Access Compliance Report

Public Rights-of-Way

Intersection ID: 21533	Main Street: LENOX_POINTE_DR	Cross Street: KINGS_PARADE_BV	Location: S
ADA ID: 8D216E91C5CC	Ramp Type: Perp	Initial Pass/Fail: Fail	Overall Compliance: No
		Severity Score: 22.5

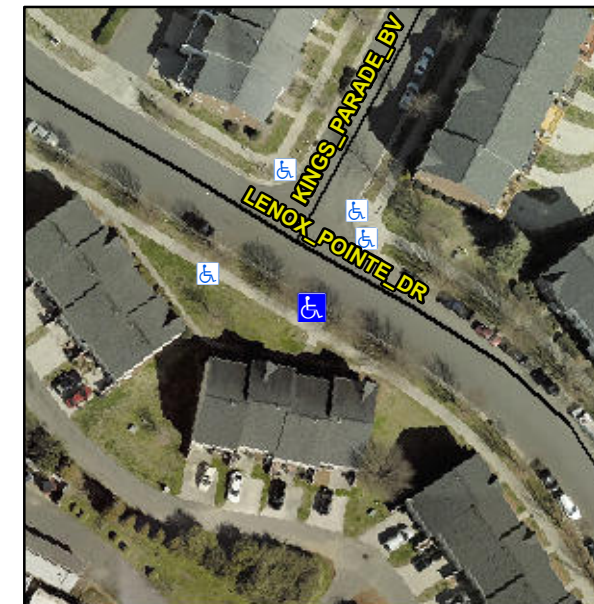
Not Found, R304.5.1, R304.2.2, R304.5.3

Compliance	Description	Data	Compliance	Description	Data
N/A	Ramp Length (in)	97.0	No	Ramp Slope (%)	10.8
No	Ramp Width (in)	47.5	No	Ramp XSlope (%)	2.4
N/A	Flare Type LT	N/A	N/A	Flare Type RT	N/A
N/A	Flare Slope LT (%)	N/A	N/A	Flare Slope RT (%)	N/A
N/A	Flare Traversable LT?	N/A	N/A	Flare Traversable RT?	N/A
N/A	Landing Length (in)	N/A	N/A	DWS Provided?	N/A
N/A	Landing Width (in)	N/A	N/A	DWS Contrast?	N/A
N/A	Landing Slope (%)	N/A	N/A	DWS Length (in)	N/A
N/A	Landing X Slope (%)	N/A	N/A	DWS Full Width?	N/A
N/A	Landing Curb? (Y/N)	N/A	N/A	DWS Offset (in)	N/A
N/A	Shared Landing?	N/A			
N/A	Gutter Ponding?	N/A	N/A	Gutter Slope (%)	N/A
N/A	Gutter Lip Ht (in)	N/A	N/A	Gutter X Slope (%)	N/A
N/A	Painted X Walk1?	No	N/A	Painted X Walk2?	N/A
	X Walk 1 Direction	To NE		X Walk 2 Direction	N/A
N/A	X Walk 1 Width (in)	N/A	N/A	X Walk 2 Width (in)	N/A
	X Walk 1 Slope (%)	2.2		X Walk 2 Slope (%)	N/A
	X Walk 1 X Slope (%)	2.2		X Walk 2 X Slope (%)	N/A

Remove & Replace Entire Ramp.
